CONTRACTOR RESPONSIBLE FOR ENSURING APPROVED DWGS ON SITE AT TIME OF INSPECTION

model
36-02

client
Tice River Homes

project
Legacy

BASEMENT FLOOR ELEV. 'A' & 'B'

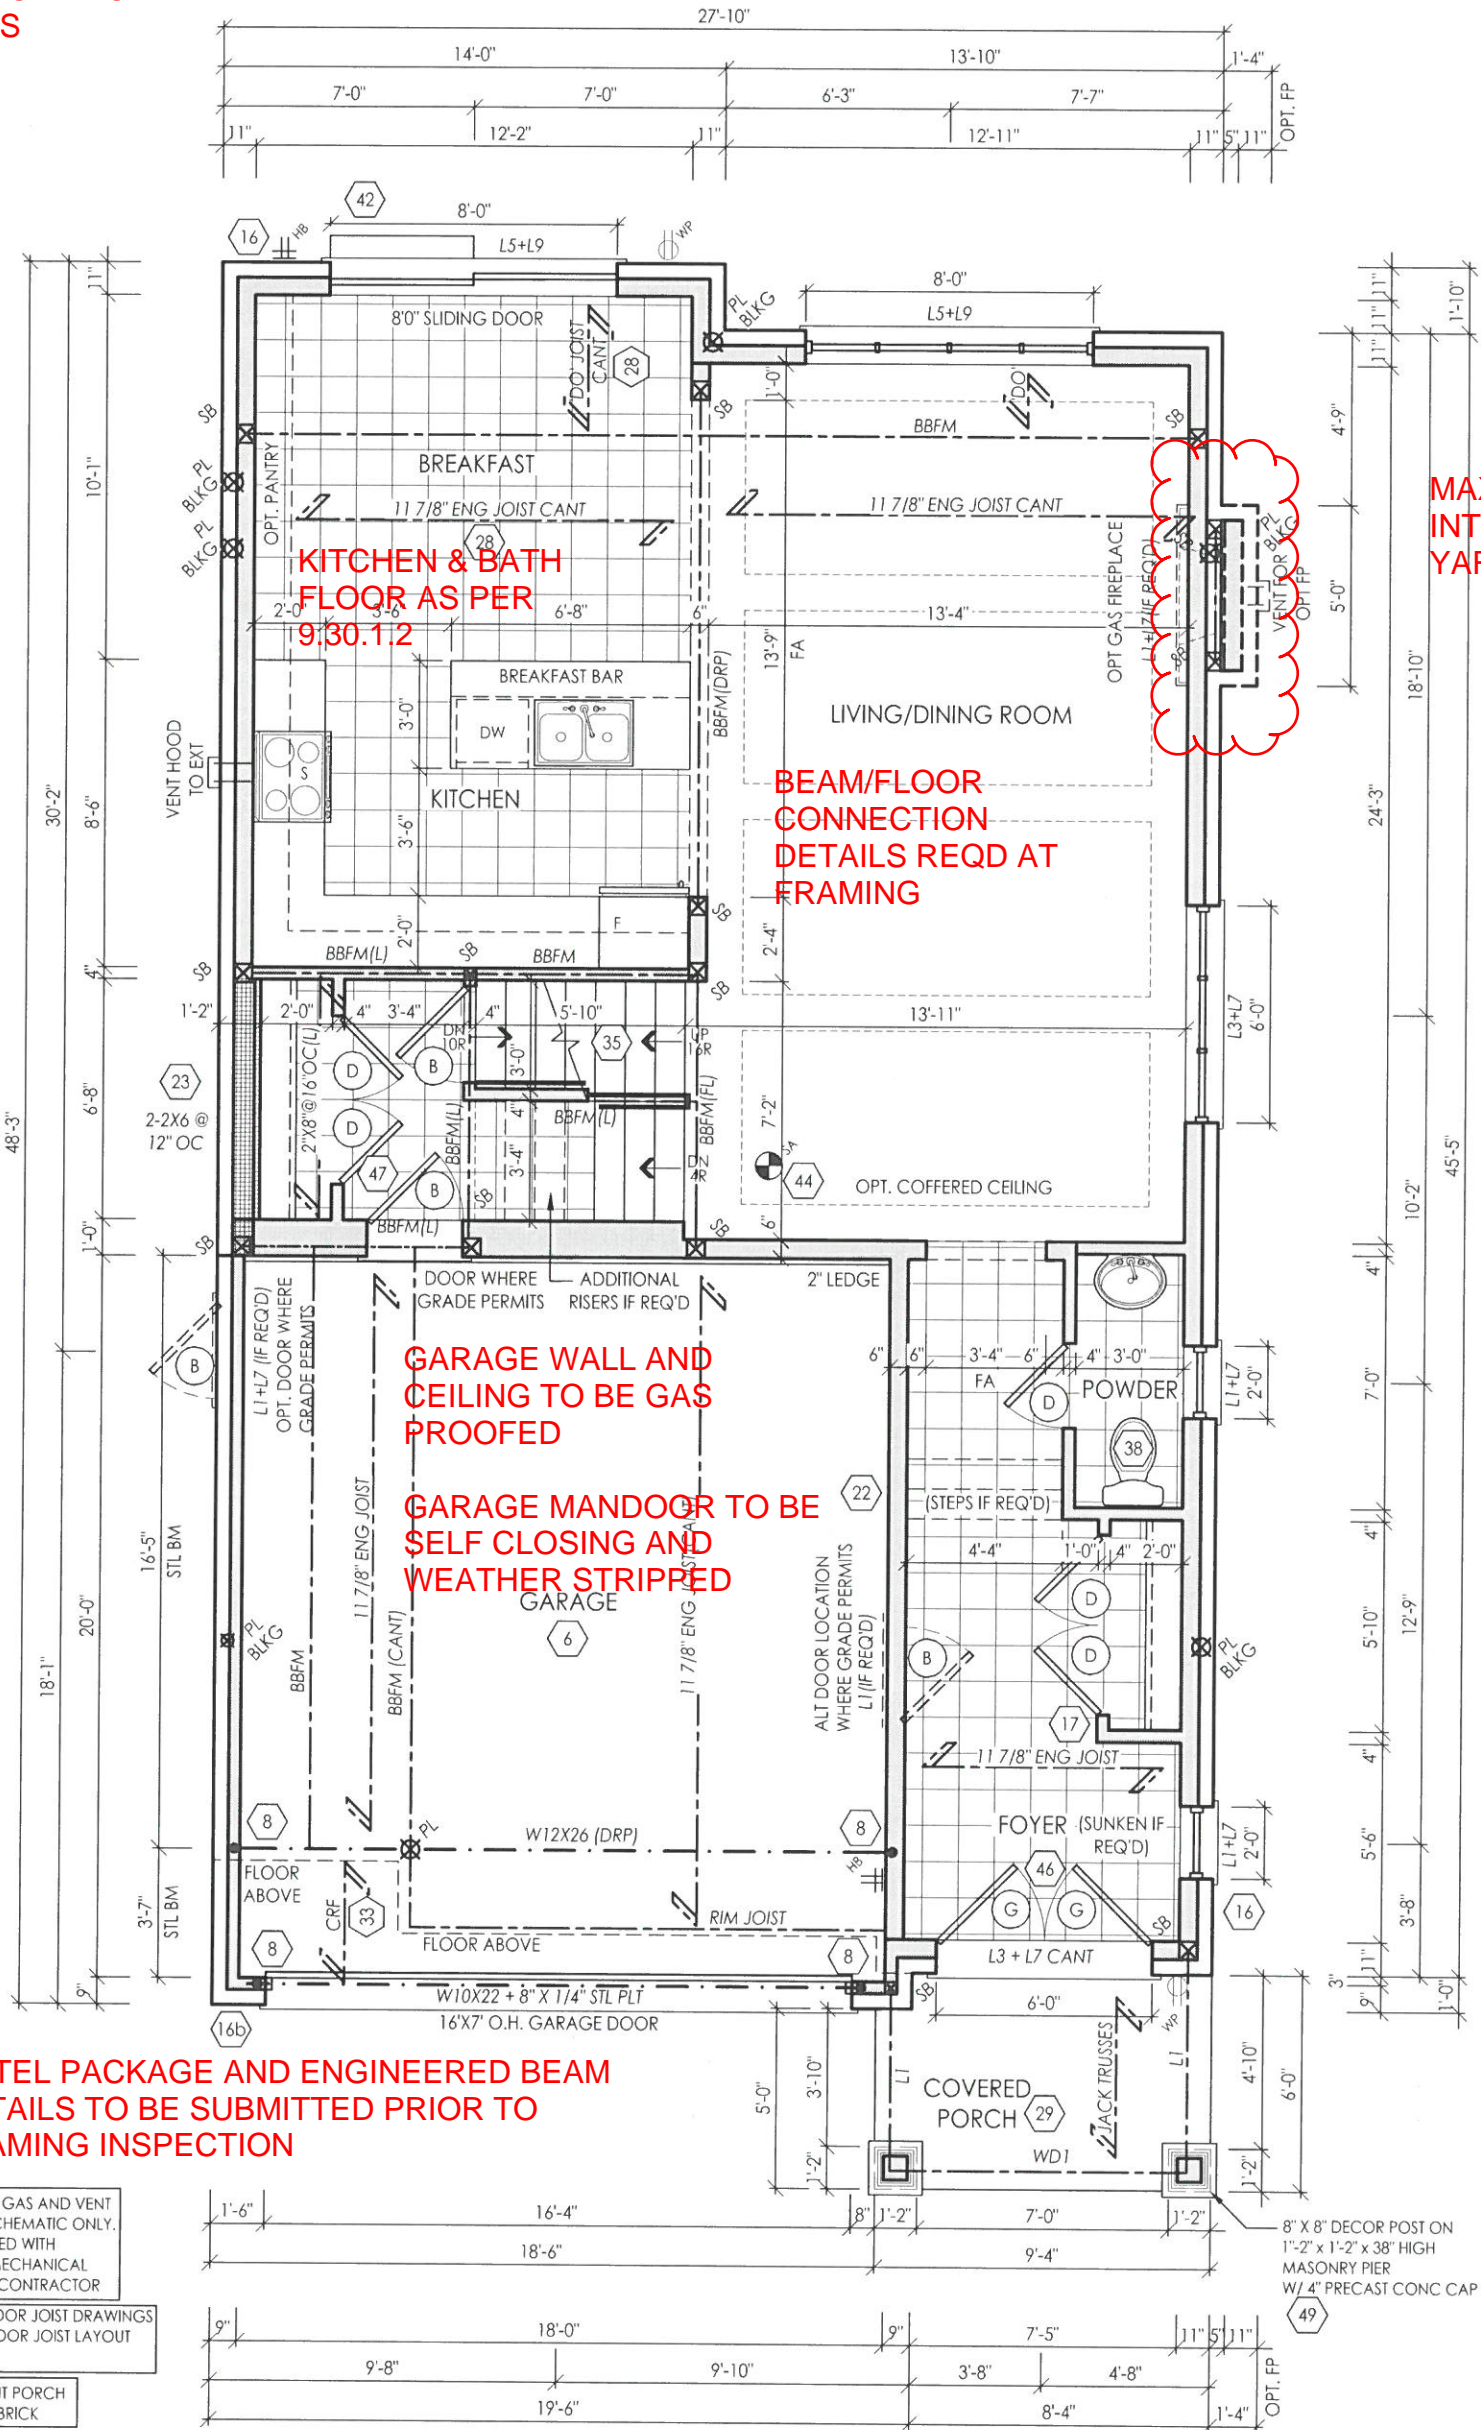
**BASEMENT AIR BARRIER
SUMP LIDS, JOINTS AT
INTERSECTIONS AND ALL
PENETRATIONS OF SLAB MUST
BE SEALED TO PREVENT AIR
LEAKAGE**

**SEPARATE
PERMIT REQD
TO FINISH BSMT**

**SUMP PIT
INSTALLED AND
CONNECTED**

**6'11 CEILING
HEIGHT REQD
OVER 75% OF BSMT
SPACE AS PER 9.5.3**

**COLD CELLAR DOOR TO BE
INSULATED AND WEATHER STRIPPED**

GROUND FLOOR ELEV. 'B'

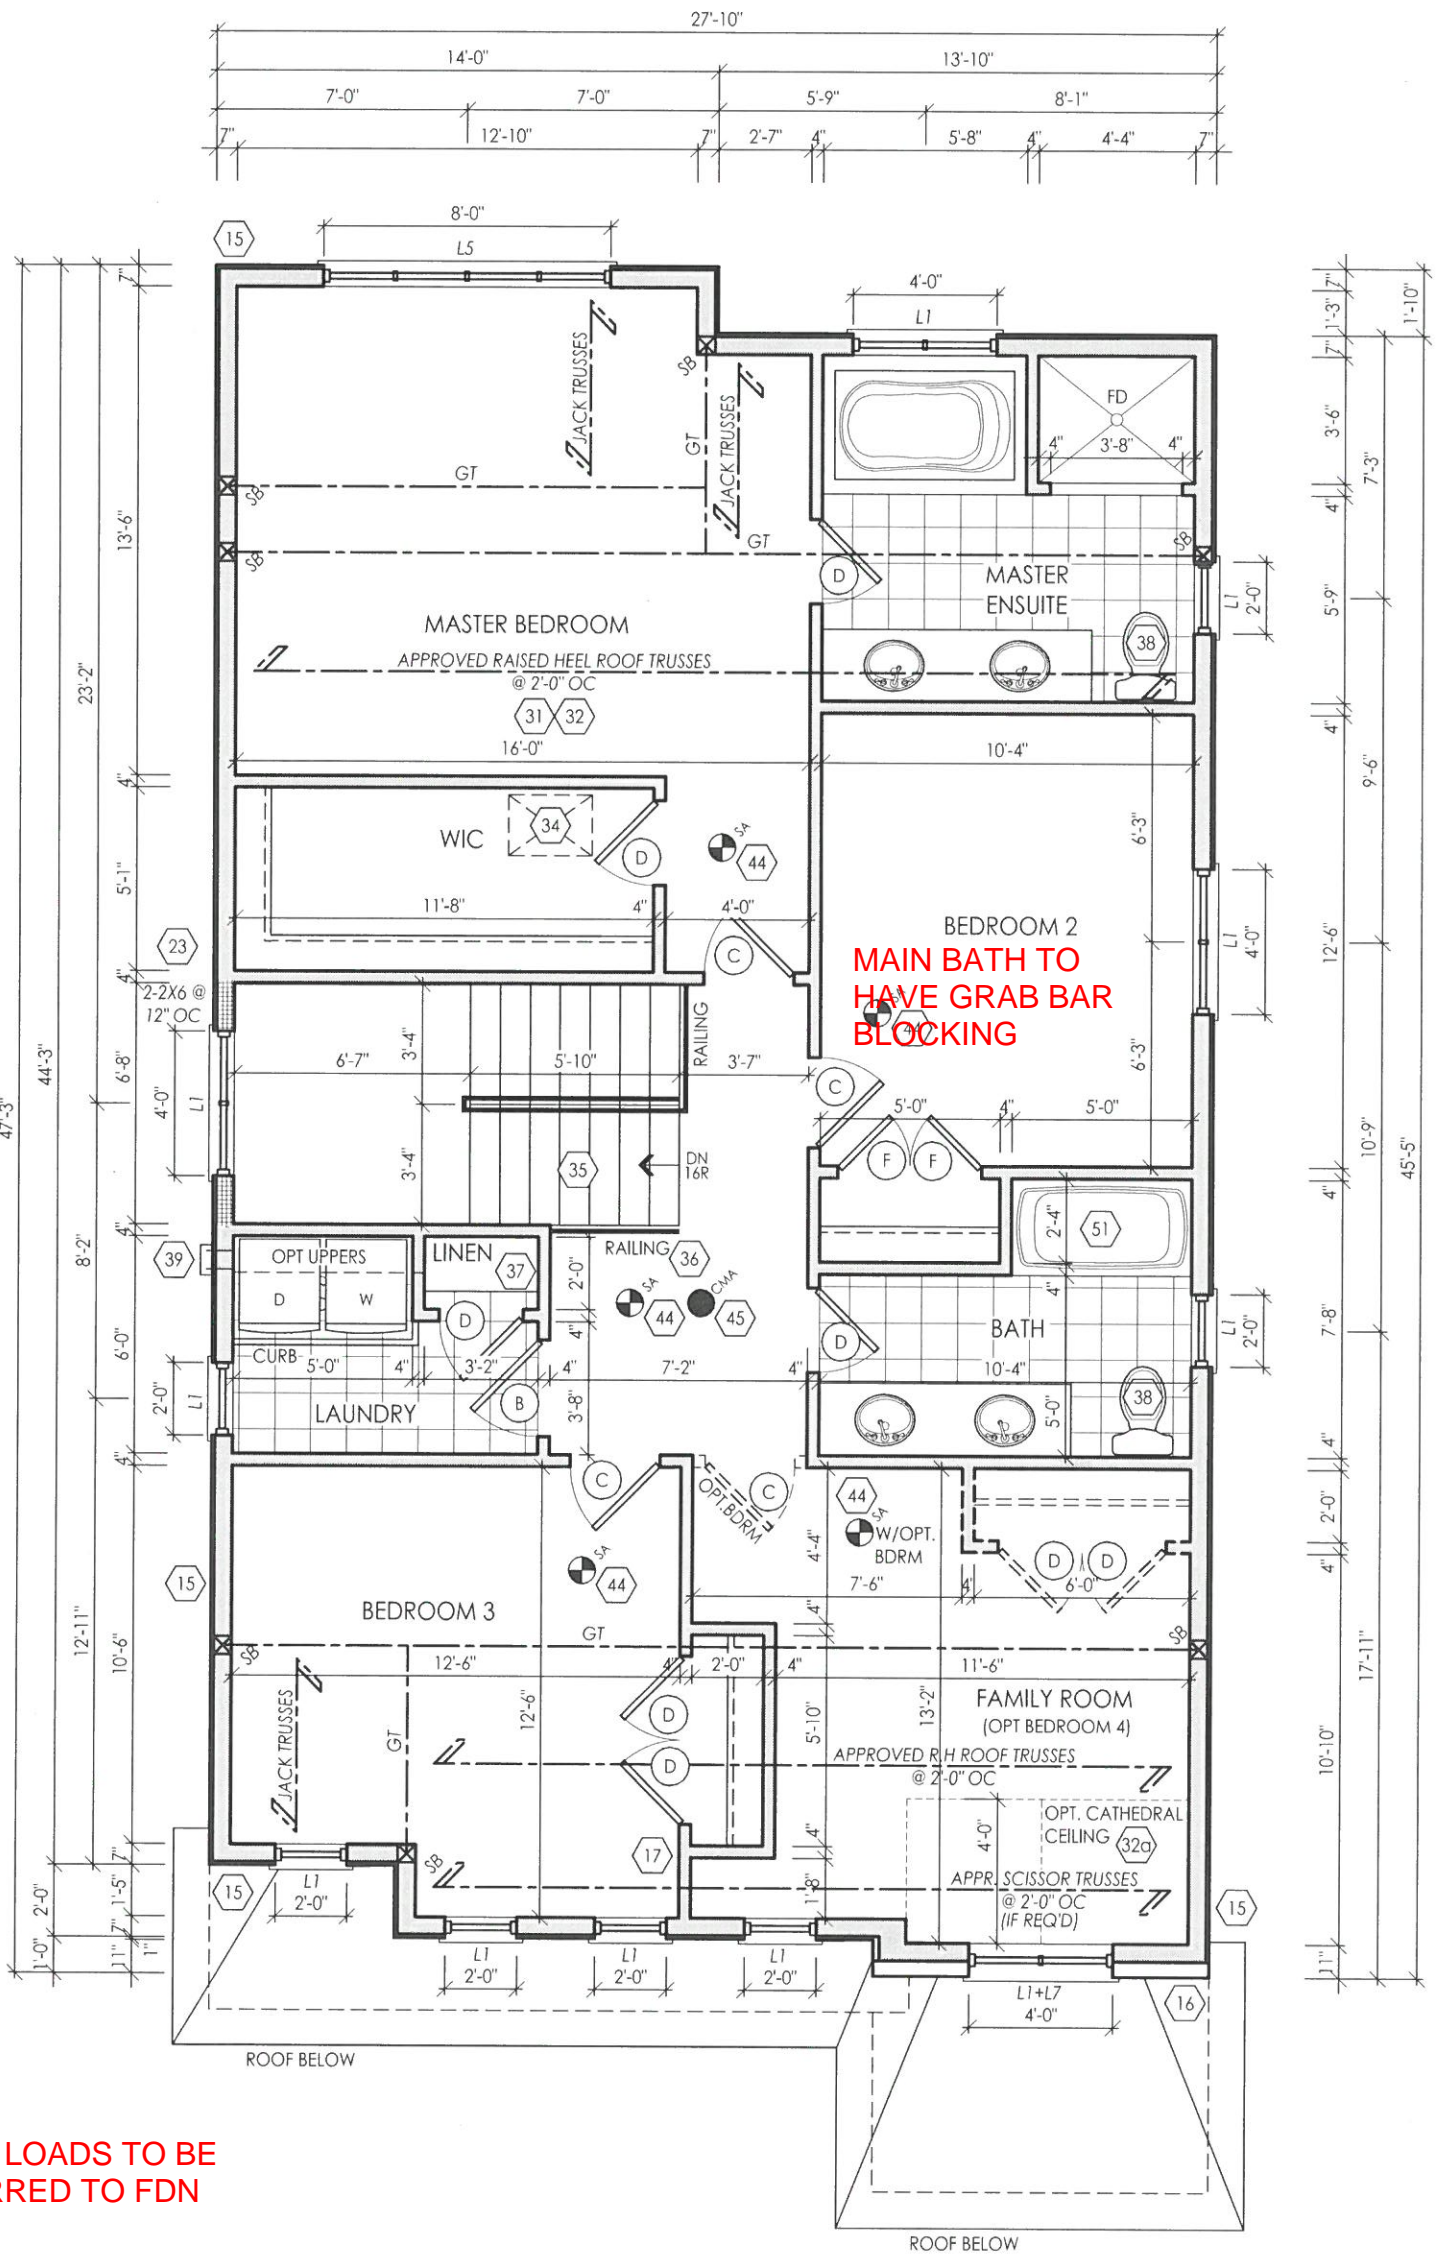
BEAM AND LINTEL
SIZES TO BE NOTED ON
FUTURE PLANS

LINTEL PACKAGE AND ENGINEERED BEAM
DETAILS TO BE SUBMITTED PRIOR TO
FRAMING INSPECTION

SECOND FLOOR ELEV. 'B'

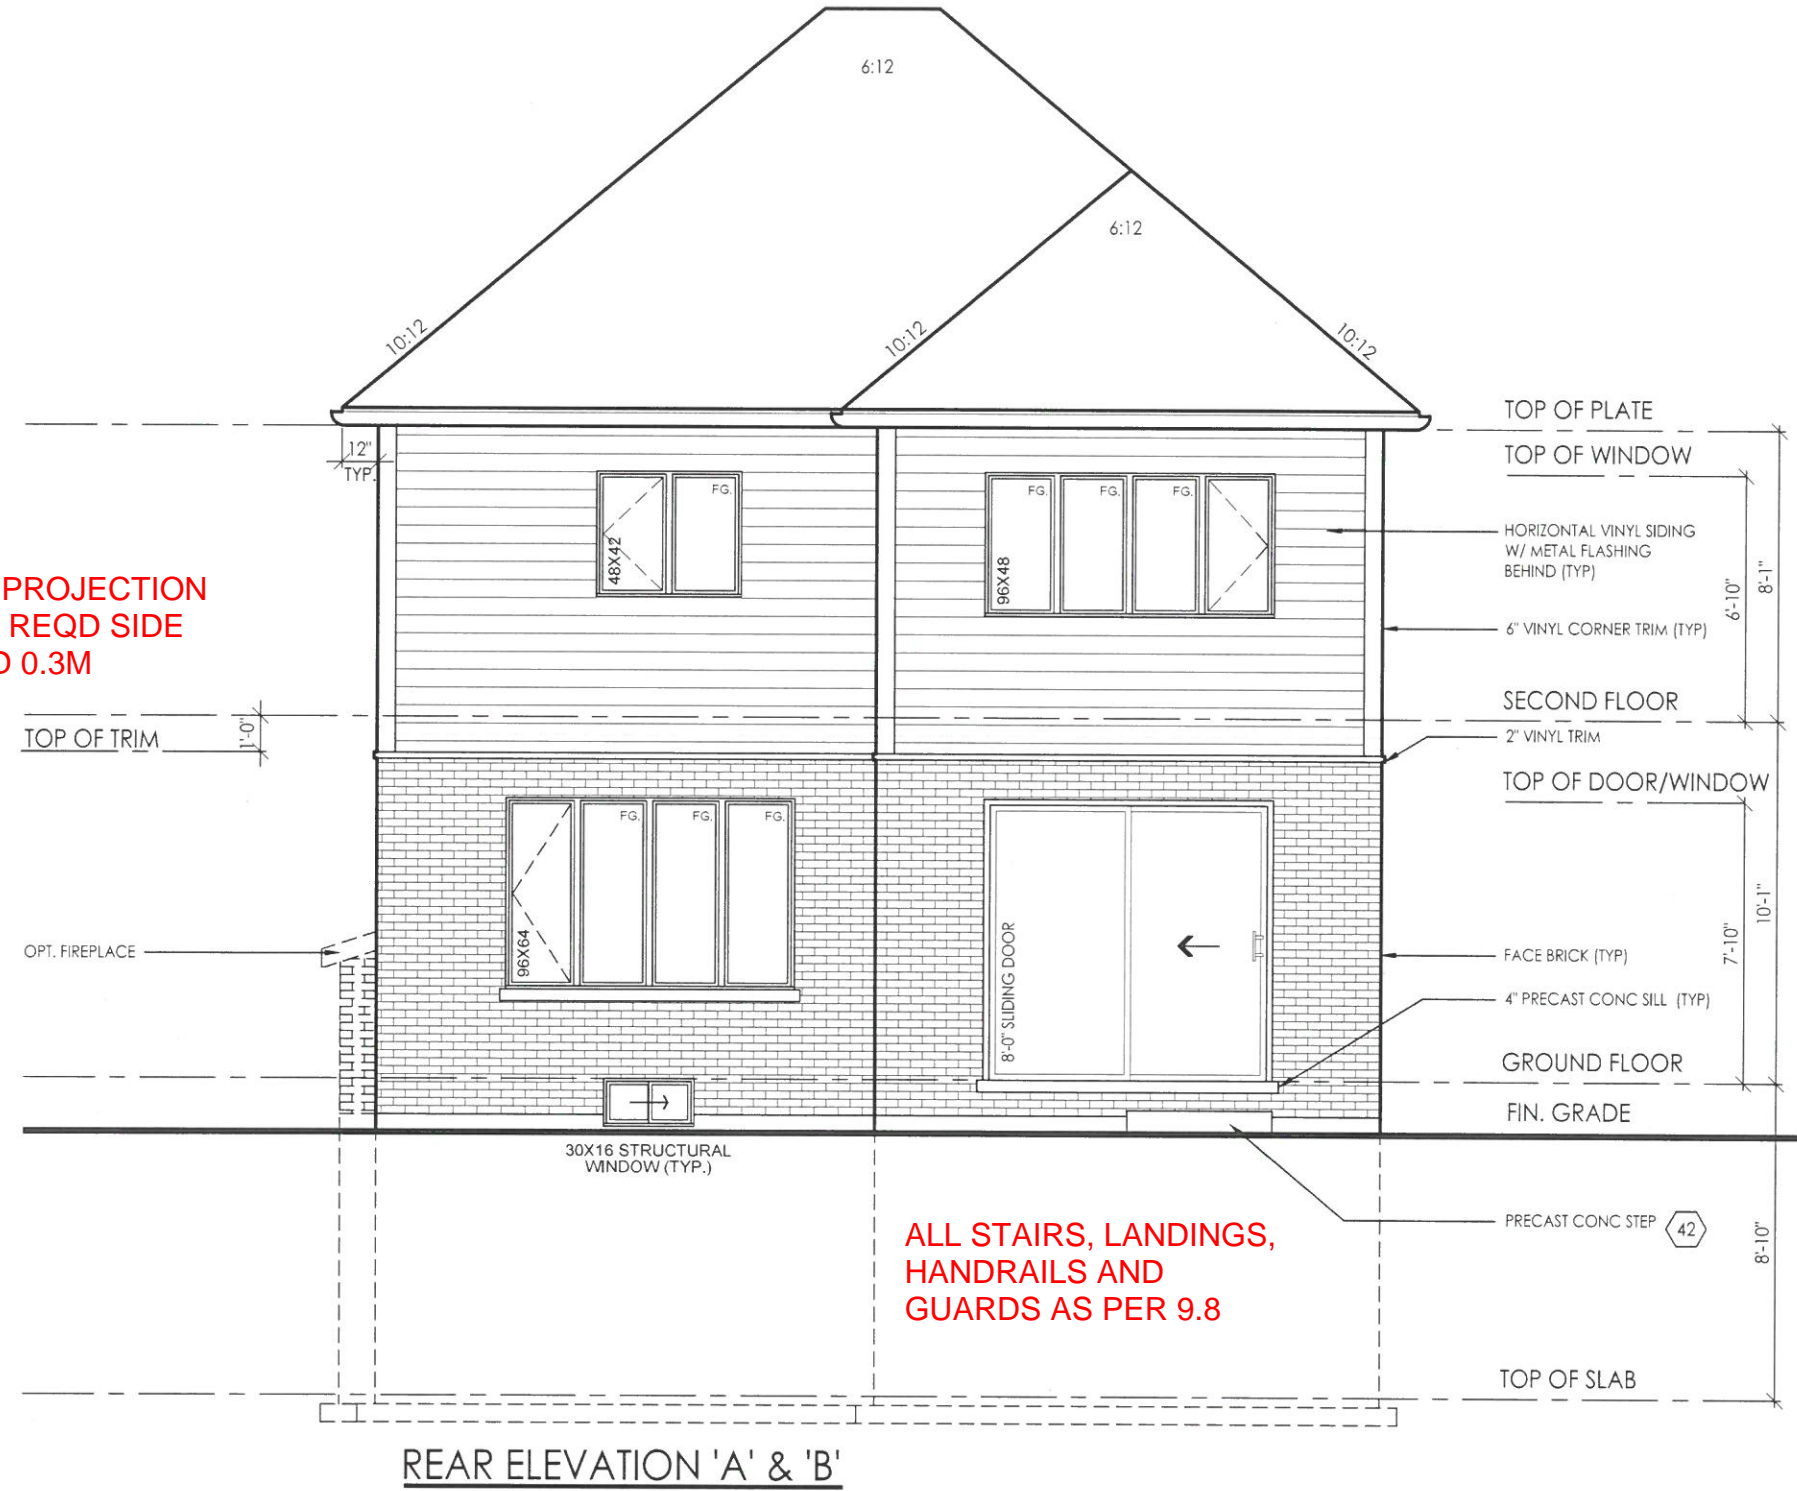
ENGINEERED FLOOR LAYOUT, TRUSSES AND LINTELS TO BE SUBMITTED PRIOR TO FRAMING. DESIGNER TO COMPLETE RESPONSIBILITY REVIEW FORM AND TO BE SUBMITTED WITH TRUSS, FLOOR AND LINTEL DOCUMENTS.

WINDOW ON LANDING MUST BE HIGHER THAN 3' ABOVE OR ENGINEERING ON WINDOW OR GUARD REQD

ALL POINT LOADS TO BE TRANSFERRED TO FDN
